FLIGHT READINESS STATEMENT
STS-109/ET-112
EXTERNAL TANK PROJECT
PRE-FLIGHT REVIEW

Space Shuttle
External Tank

Pre-Flight Review

STS-109/ET-112

Ullage Pressure Transducers / Flex Hoses
(LH2 installation shown)

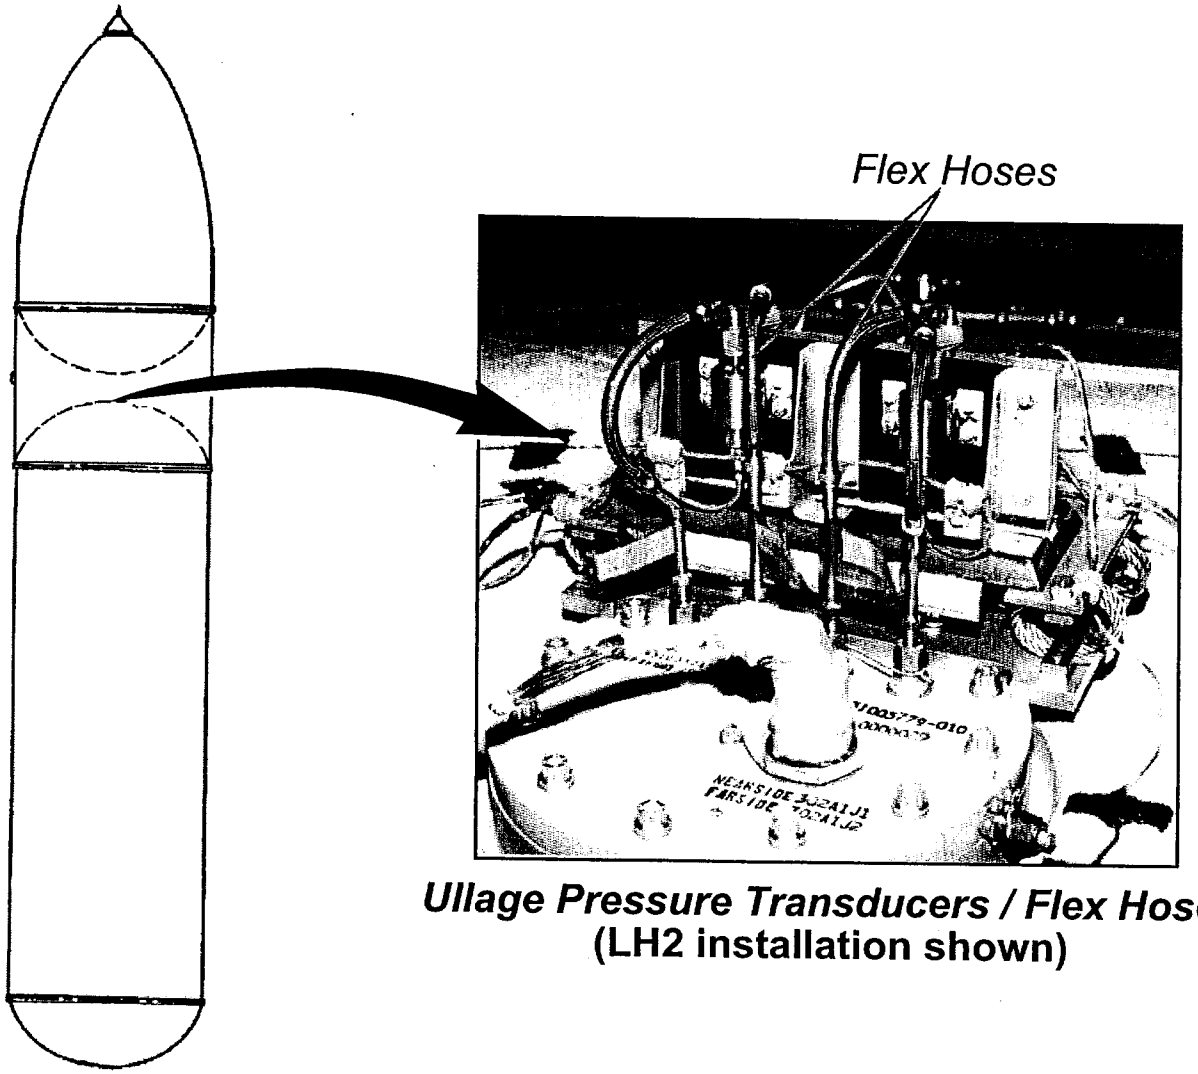
- Supplier of LO2 (32L10) and LH2 (32L8) ullage pressure transducer flexible hoses revised manufacturing process used to fabricate convoluted Teflon line in hoses
  - Was
    - Teflon tube was helically convoluted at RT by putting straight tube over a convoluting mandrel and winding a stainless steel wire around the tube
    - The wire remained in place as the tube was removed from the mandrel and the assembly was placed in the oven and baked to set the convolutes
  - Now
    - Teflon tube is helically convoluted in a heated chamber where a die is used to form the outside diameter
    - The straight tube enters the chamber, is heated, and convoluted by the die

- Supplier exhausted supply of liner material used for 32L8 and 32L10 hoses
  - Original tooling used to produce hoses no longer available
- 32L8 and 32L10 hoses are identical in diameter and assembly
  - 32L10 hoses, used for LO2 ullage pressure transducers, are cleaned to more stringent requirement

- No change in material or dimensions
  - Only convoluting process changed
- No change in acceptance tests (leakage, burst and x-ray)
- Test - Random and Sinusoidal Vibration
  - Strength – No sign of damage from impact or fatigue
  - Leak – No degradation in the pressure decay
  - New hoses did not alter the response of the isolation platforms

New Mandrels for LH2 Tank Circumferential Welds

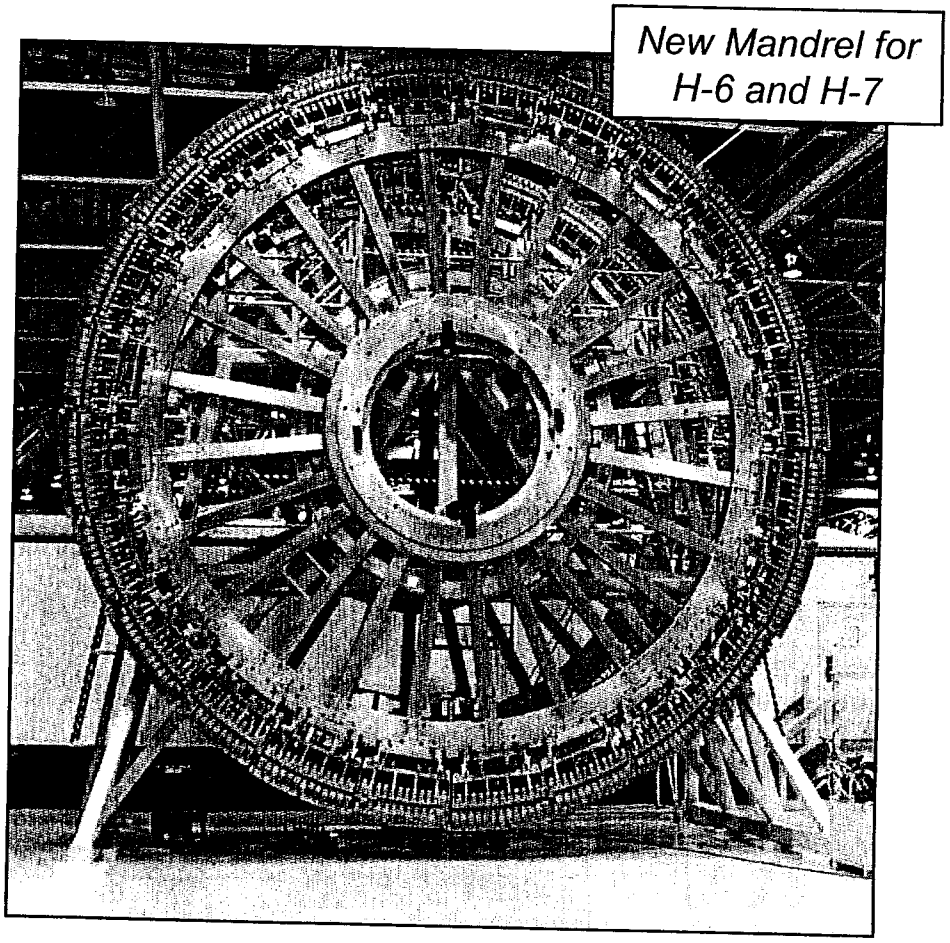
- Replaced one mandrel and added a mandrel on two LH2 tank major weld tools
  - Replaced purge box with static purge chamber
  - Modified tools to accept new weld process flow
    - Was: Welds H1 through H7 were performed on 5019
    - Now: Welds H1 through H5 performed on 5019 and welds H6 and H7 performed on 5068
      - 5069 tool modified to accept 3 barrel tank (shorter assembly)
- No change to weld processes or hardware configuration

- Reliability / Producibility
  - Previous mandrel design had purge box that tracked with the torch to maintain a backside shield gas envelope
    - Purge interruptions due to the box resulted in weld defect NCDs
    - New mandrel static purge provides reliable back side shield gas independent of the torch position
  - Mandrel change allows parallel processing of tank barrels
    - Welds H1 through H5 on 5019 tool
    - Welds H6 and H7 on 5068
  - New mandrels have 60% fewer parts than old mandrels

- Tool Mod Certification
  - Weld Schedule Certification
  - Full Size H2 and H3 Pathfinder Verification

- Flight Hardware Certification – Unchanged from prior vehicles
  - Proof test demonstrates minimum of 111% of design limit load
  - Post-proof inspection (Penetrant and X-ray)

Use of New LH2 Tank Ice/Frost Ramp Mold

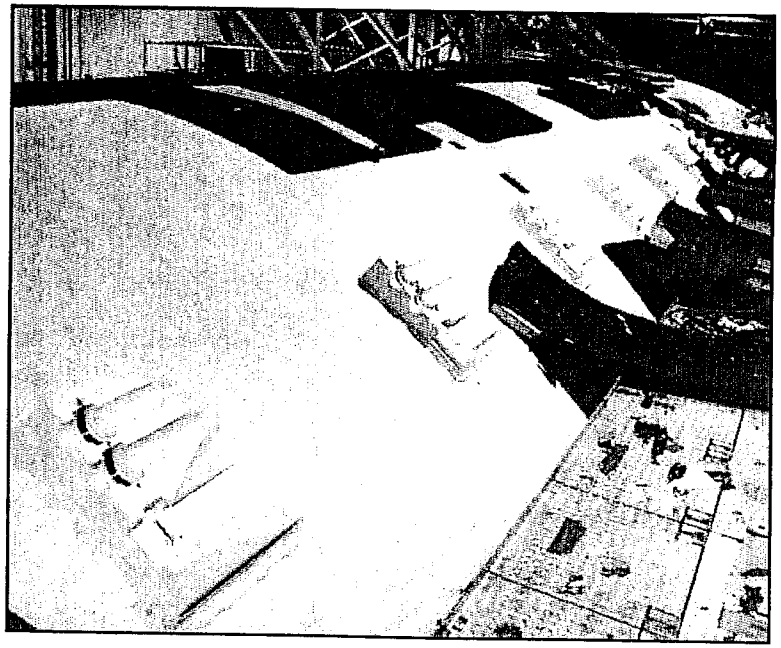
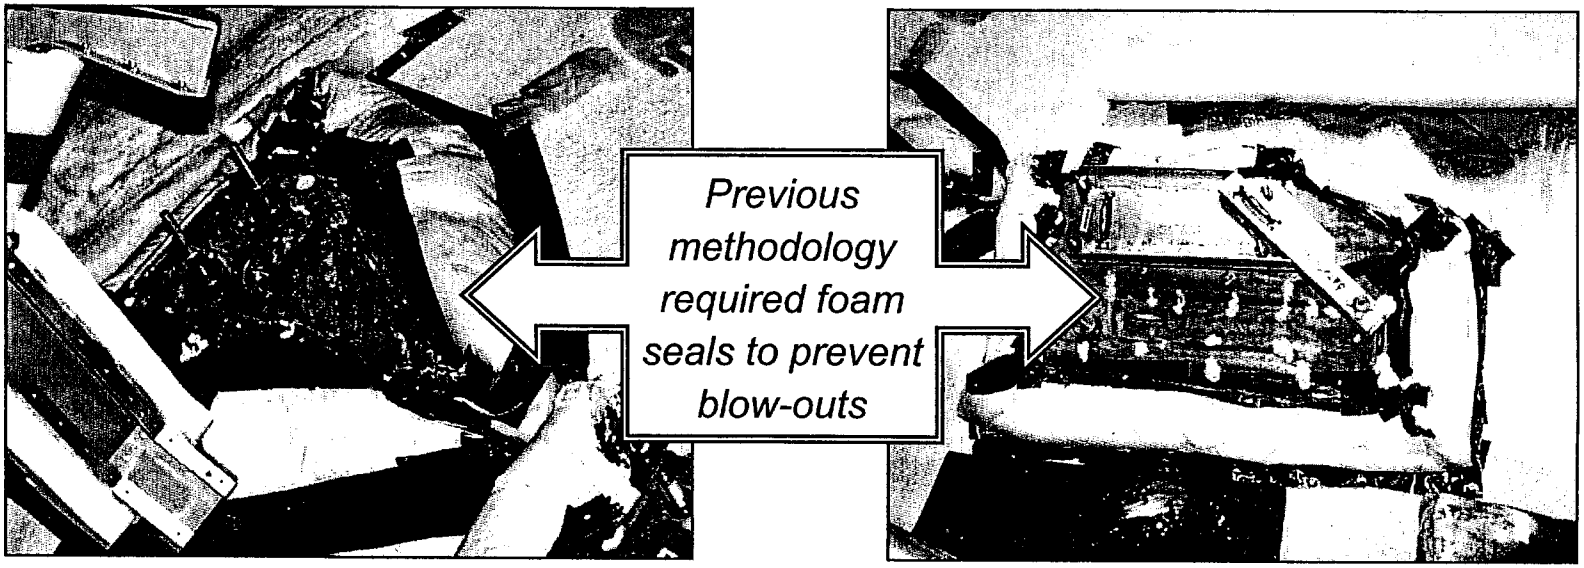
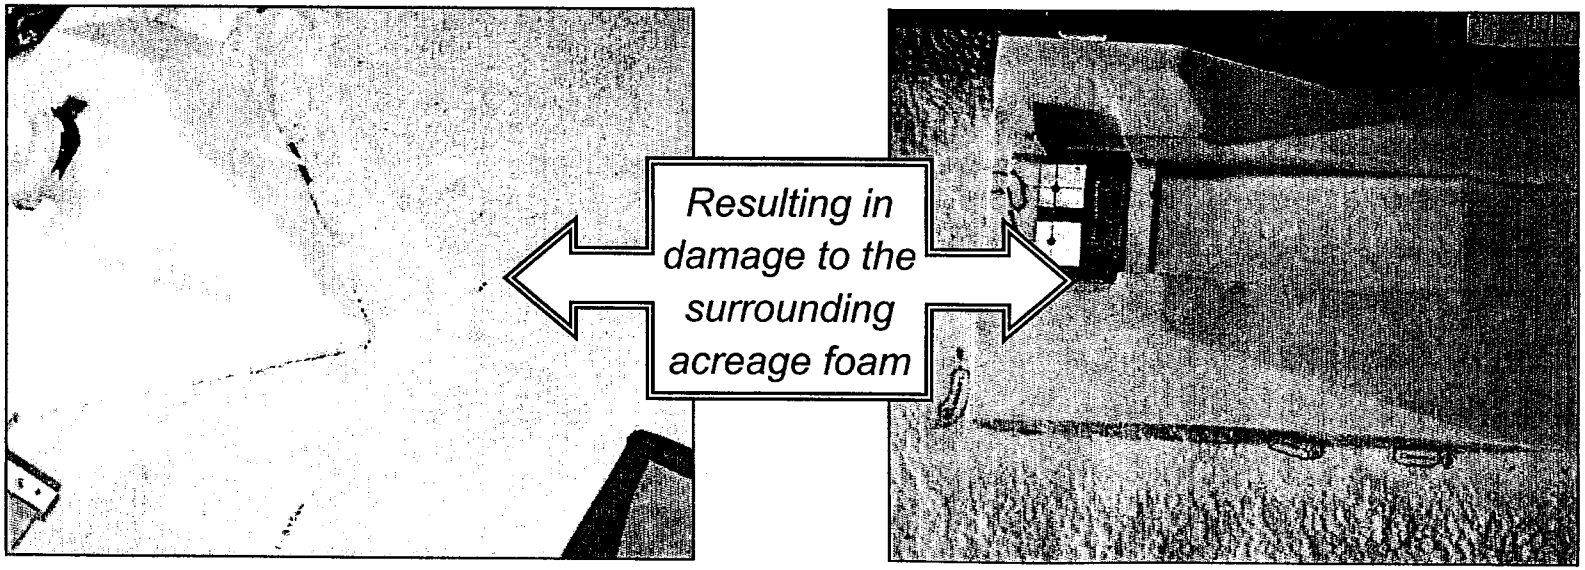
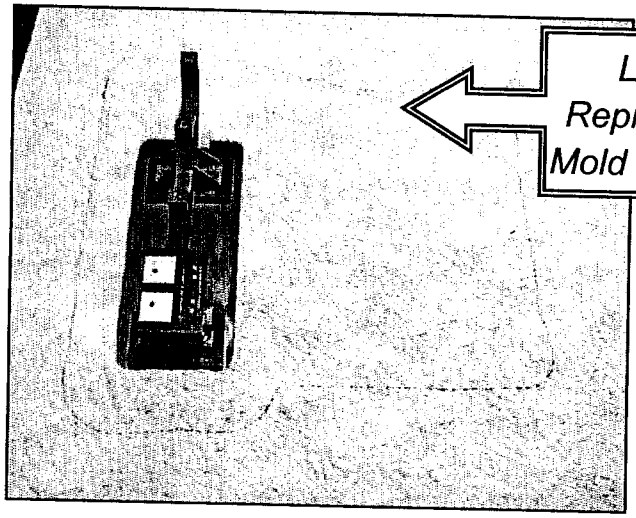
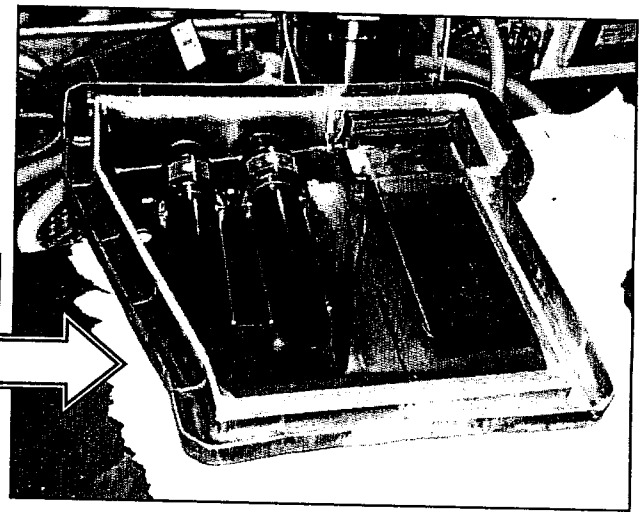
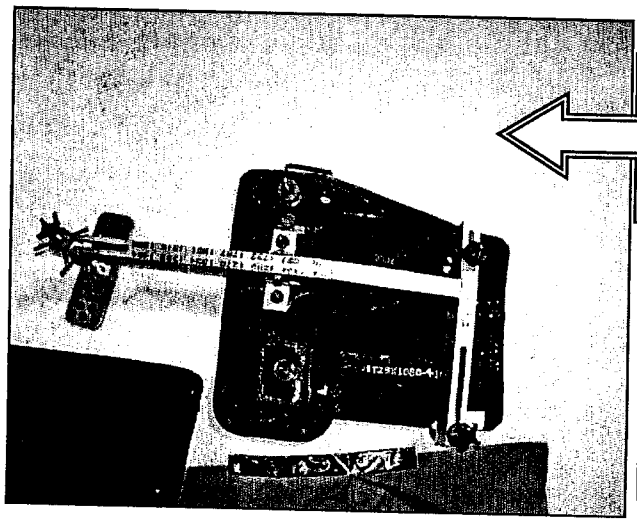
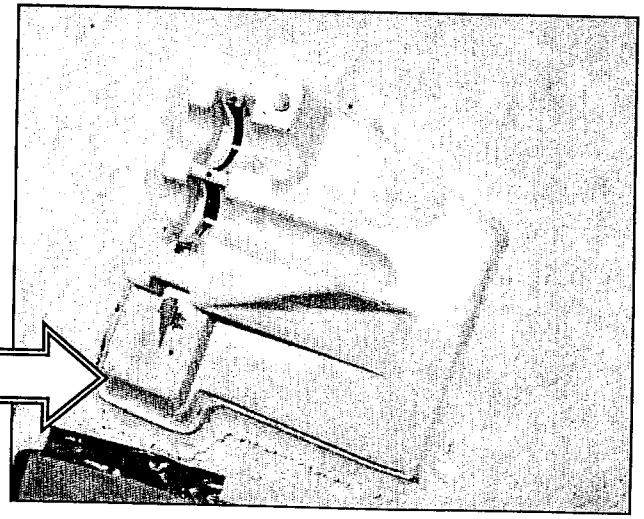
- Revised ice/frost foam molds for the closeouts at each of the LH2 tank press. line / cable tray supports
  - Was: Mold used bag with PDL as barrier to retain foam
  - Now: Mold incorporated bladder to retain foam material
- Revised mold drawing to include minor foam dimensional change to accommodate the new mold (H36809-492)

- Producibility change
  - New foam retention seal design reduces acreage foam damage
  - Eliminate rework and non-conformances
    - Average number of ice/frost ramp NCDs for 4 previous ETs = 16
    - Average number of ice/frost ramp NCDs for current tanks = 7.8
      - Saved over 250 labor hours, 24 critical path flow hours, and over $1,000 in material for ET-112

Prior Tool - Mold using bag with PDL as barrier to retain foam

Previous methodology required foam seals to prevent blow-outs

Resulting in damage to the surrounding acreage foam

New Tool - Mold incorporated bladder to retain foam material

- Test - Molds were validated per engineering requirements
  - Two successive, successful applications that met bond adhesion, dissection and visual inspection requirements
- Similarity – Ramps using new mold design met existing engineering requirements
  - Verification of Shore "A" 70 hardness requirements
  - Dimension within existing mold schedule
  - No change to surface finish, moldlines or airloads

LO2 Tank Dome Cap Reallocation (J31208/B02035)

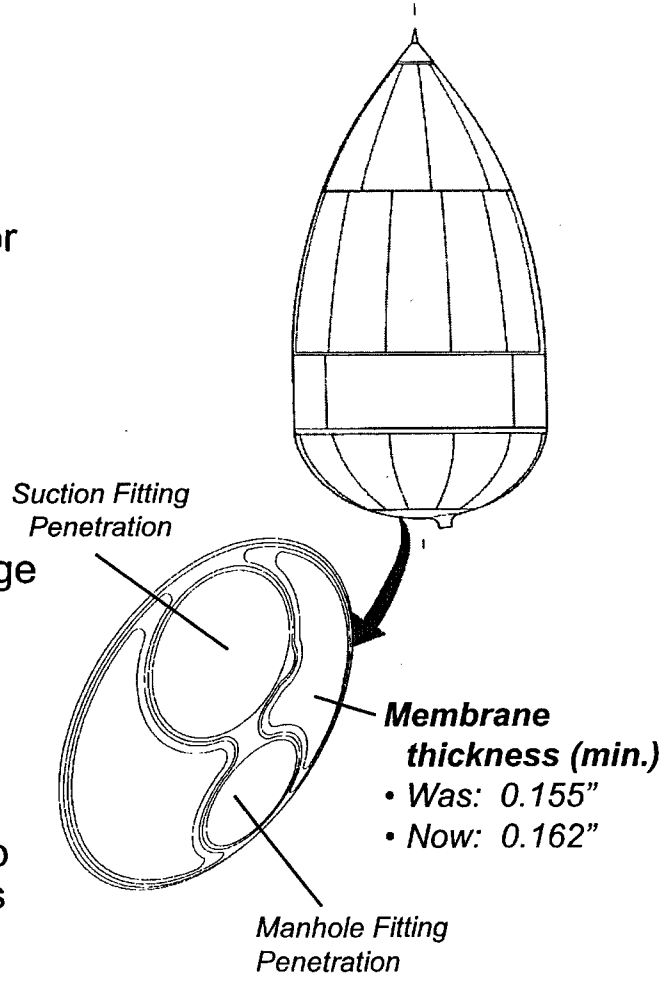
- Reallocated ET-115 (as-planned) LO2 tank dome cap to ET-112 LO2 tank aft dome (as-built)
  - ET-112 dome cap needed for ET-102 due to welding issues with ET-102 as-planned dome
  - Dome cap acreage membrane thickness increased for ET-115 and subs (+8 lbs)
    - Basic cap design configuration is unchanged (i.e. material, weld land widths, weld land thickness)

- SSP (Level II) requested External Tank certification to higher maximum LO2 tank ullage pressure operating range (expansion of ICD requirements)
  - ICD pressure increase required to allow the Orbiter fleet to use any combination of spare GO2 fixed orifices beginning at ET-115

- Certification to the higher pressures required increases to the LO2 proof test pressures, barrel membrane thickness and dome cap membrane thickness
  - Barrel design and proof pressure changes to be implemented (as planned) and presented at ET-115 readiness reviews

- Similarity
  - Basic dome cap design configuration is unchanged from previous design
    - Only change is increase in membrane thickness

- Test
  - Proof test demonstrates a minimum of 120% of design limit load

- Analysis
  - Stress analysis shows improved Factors of Safety for redesigned cap implemented at ET-112
    - Proof and flight pressure requirements are unchanged at ET-112

Repair Suspect LH2 Line Burst Discs (FEC KET-0077)

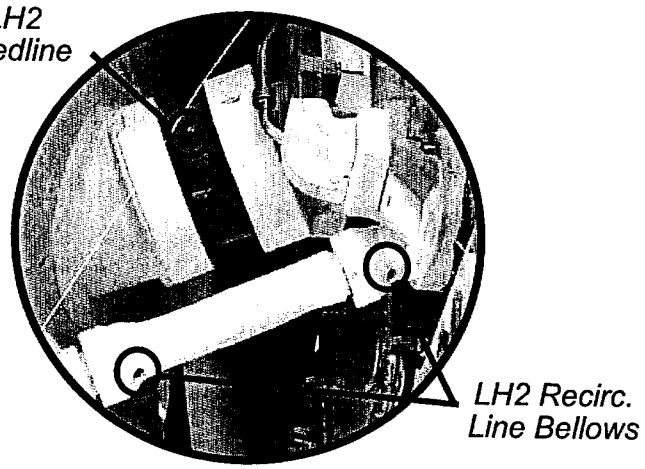
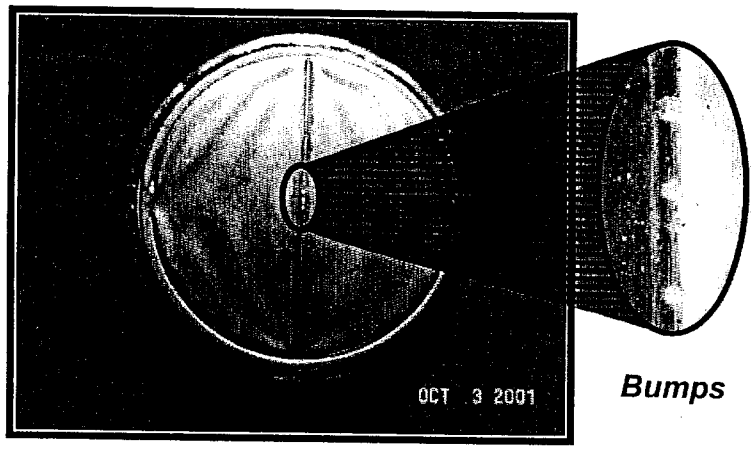
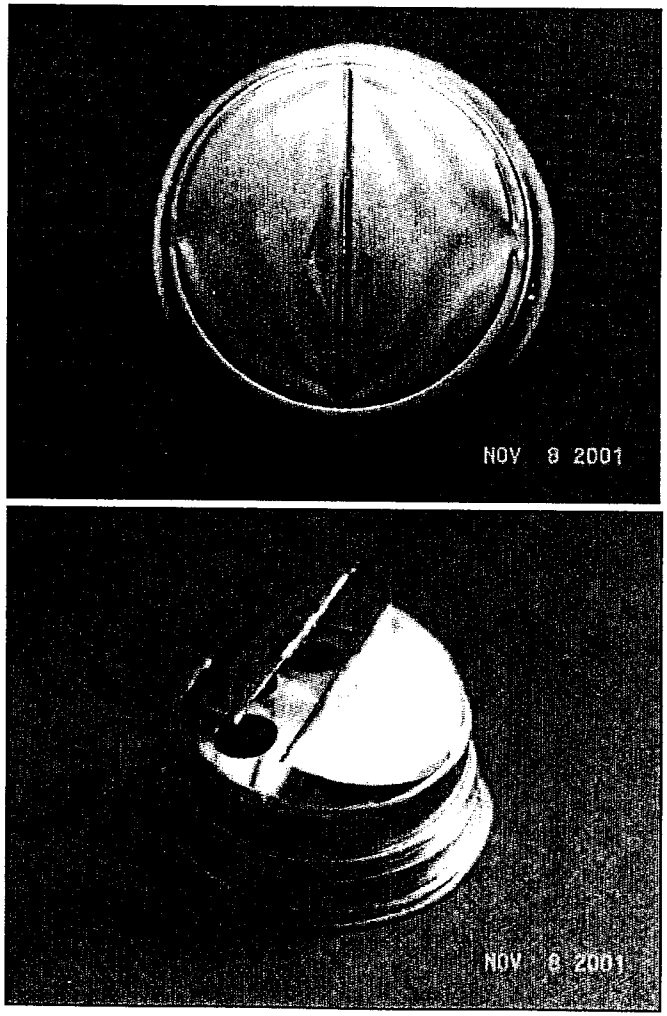
- Implement a repair on suspect burst discs to prevent suspect leakage

- Burst disc is a safety feature on jacketed lines to prevent hardware damage due to annulus over-pressure
  - Three burst discs are installed on each ET
- During a supplier ATP burst discs leaked
  - Leakage at microscopic cracks observed on the part during failure analysis
  - Cracking observed only on small "bumps" in the center of the disc

Typical Crack
Approx. 0.008" in length

- Cleaning and application methods were validated on available burst disc assemblies
  - Performed through burst disc shield
- Repaired a total of 17 burst discs per established procedure
  - All repairs witnessed/verified by quality representative
  - Six discs had known leakage
  - Eleven had no leaks
- Performed 13 simulated operational cycles on each of the 17 discs
  - Demonstrated the ability of repair to eliminate / prevent leakage on hardware
  - No leakage was detected during testing
- Verified burst pressure all discs
  - All burst within ATP requirement of 35±15 psid

- Test
  - Method to repair remaining suspect burst discs using Conathane primer developed and validated
    - Repair prevents leakage of burst disc during operations
    - All materials are approved for use on ET flight hardware
    - Testing demonstrated that Conathane repair does not affect the burst pressure of the disc
